UNITED STATES  
NUCLEAR REGULATORY COMMISSION  
OFFICE OF NUCLEAR REACTOR REGULATION  
WASHINGTON, D.C. 20555

June 9, 1993

NRC INFORMATION NOTICE 93-42: FAILURE OF ANTI-ROTATION KEYS IN MOTOR-OPERATED VALVES MANUFACTURED BY VELAN

# VELAN VALVE AND ANTI-ROTATION KEY

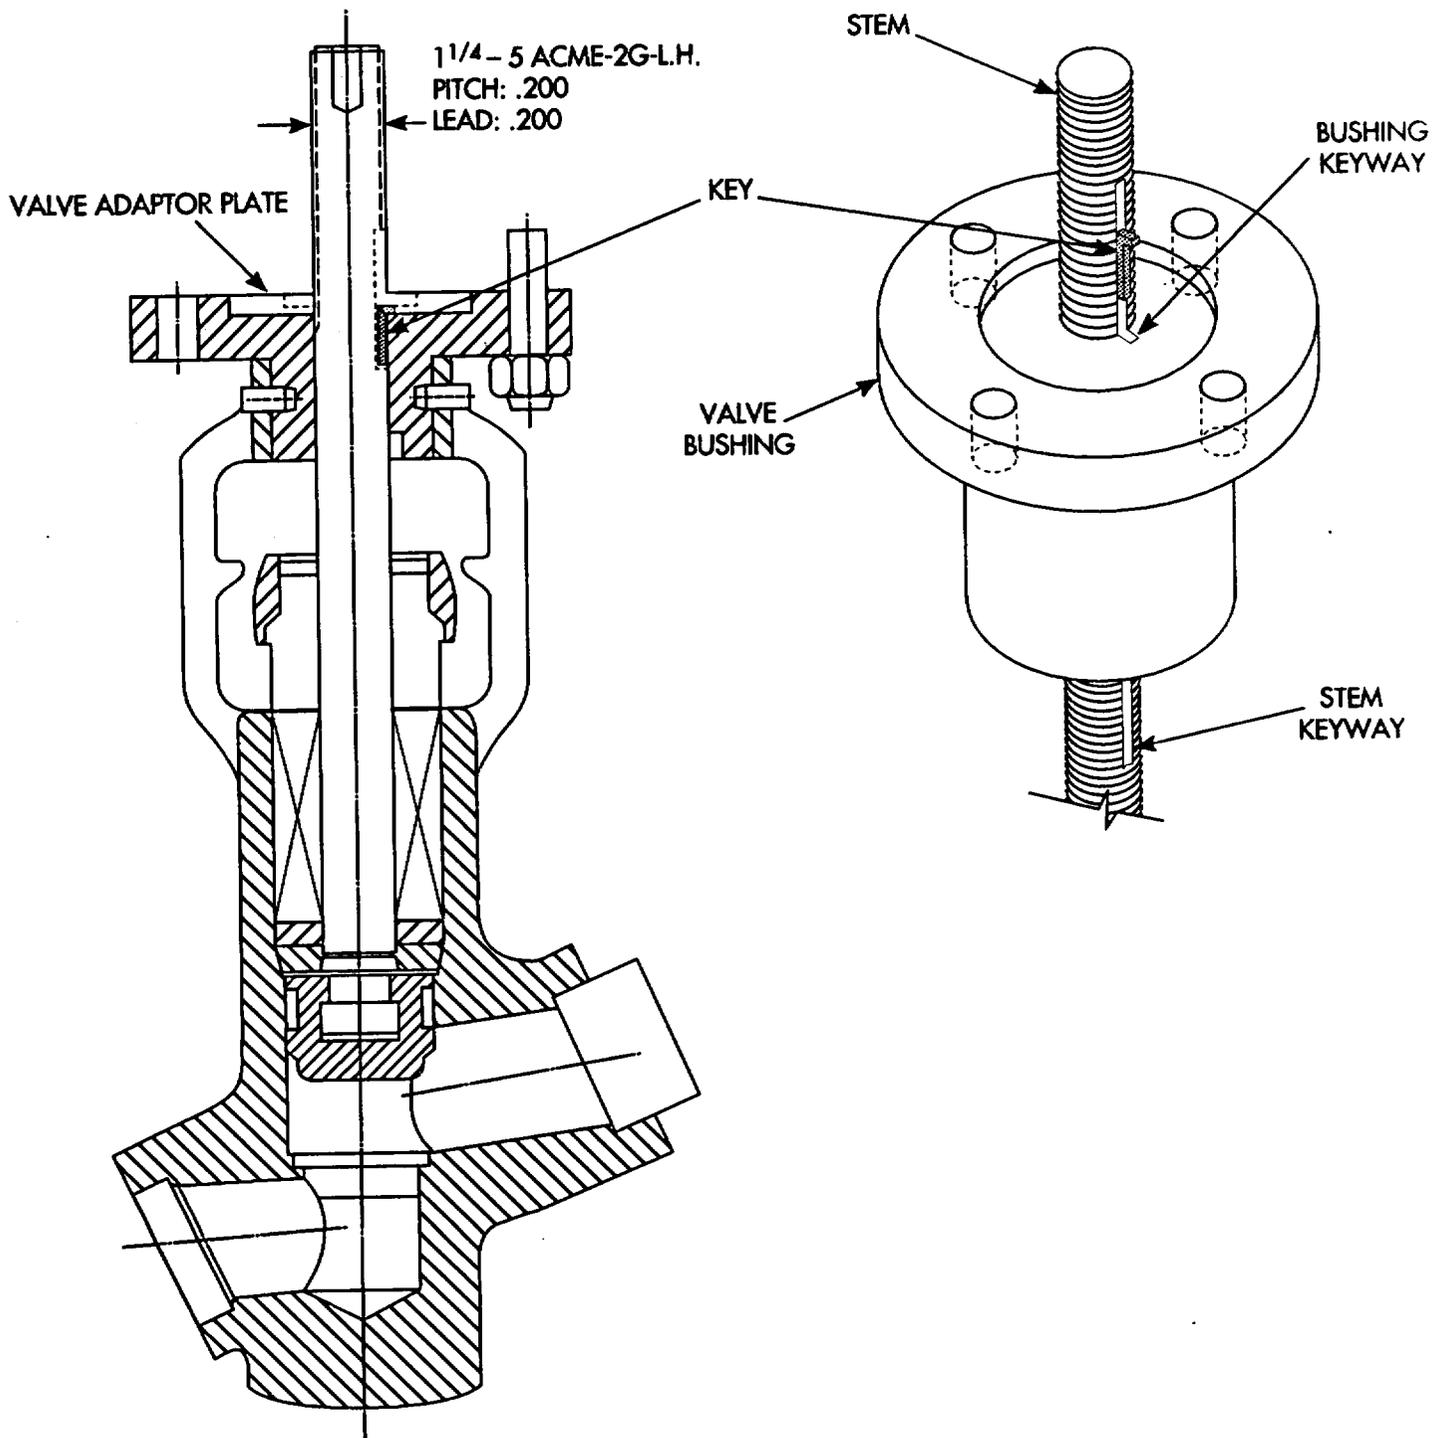
On March 28, 1993, Wisconsin Public Service Corporation, the licensee for Kewaunee Nuclear Power Plant, reported that during motor-operated valve (MOV) dynamic testing on March 27, 1993, one of two redundant safety injection recirculation valves to the refueling water storage tank failed to close completely. Investigation revealed that the anti-rotation device, an L-shaped key between the valve stem and the yoke bushing (Attachment 1), had broken. The shorter part of the broken L-shaped key had apparently worked its way toward the valve stem and had jammed the valve stem, preventing closing. The valve that failed was a 2-inch bonnetless globe valve manufactured by Velan Valve Corp. The licensee inspected all nine similar motor-operated valves and found that six had broken anti-rotation keys. The inspections were visual and did not require disassembly of the motor-operated valve. Failures usually can be observed on normally closed valves, since the broken long leg of the L-shaped key slides down partially and becomes visible below the yoke bushing.

According to the licensee, the keys failed in a brittle manner. The fractures began on either side of the key at the sharp radius of the inside corner of the L-shaped key and propagated into the body of the key. Machining of the sharp inside corner of the L-shaped key may have contributed to the failure of the anti-rotation keys by producing high stresses in the corner of the keys. It is likely that the rotational action of the valve stem impacted on both sides of the key, exceeding the impact strength of the material at the sharp radius of the key.

Based on the incident at Kewaunee Nuclear Plant we recommend that keys be inspected for possible wear which could result in failure. Consideration should also be given to replacing keys at your earliest possible convenience with new keys. These new keys are supplied in material meeting AISI 4140. This material replaces the 440C grade which several project drawings call up.

On April 5, 1993, Velan issued the attached (Attachment 2) Service Bulletin #SB-106. This bulletin recommends that the anti-rotation keys be inspected for possible wear which could result in failure and that consideration be given to replacing the keys at the earliest convenient time. The replacement keys, which have been supplied by Velan for the past 2½ years, are made of material meeting American Iron and Steel Institute (AISI) 4140 alloy steel, as opposed to 440C stainless steel (440C SS). AISI 4140 is significantly tougher than 440C SS. According to Velan, the material was changed to 4140 because 4140 is easier to procure and to heat treat properly. Velan plans to send this bulletin to all U.S. nuclear utilities. On the basis of conversations between the NRC staff and Velan subsequent to the issuance of the bulletin, and because of the hardness of anti-rotation keys made out of 440C SS, Velan suggests that both the keys and the keyways be inspected for damage and deterioration. The experience cited above indicates that the use of brittle material in anti-rotation keys can lead to failures, although valve operation may not always be impaired.

Replacement keys which have been supplied by us during the last 2 1/2 years have been from this new material. If these have been installed, only regular periodic verification will be required. If no inspection and or replacements has been made, we recommend that keys be replaced.
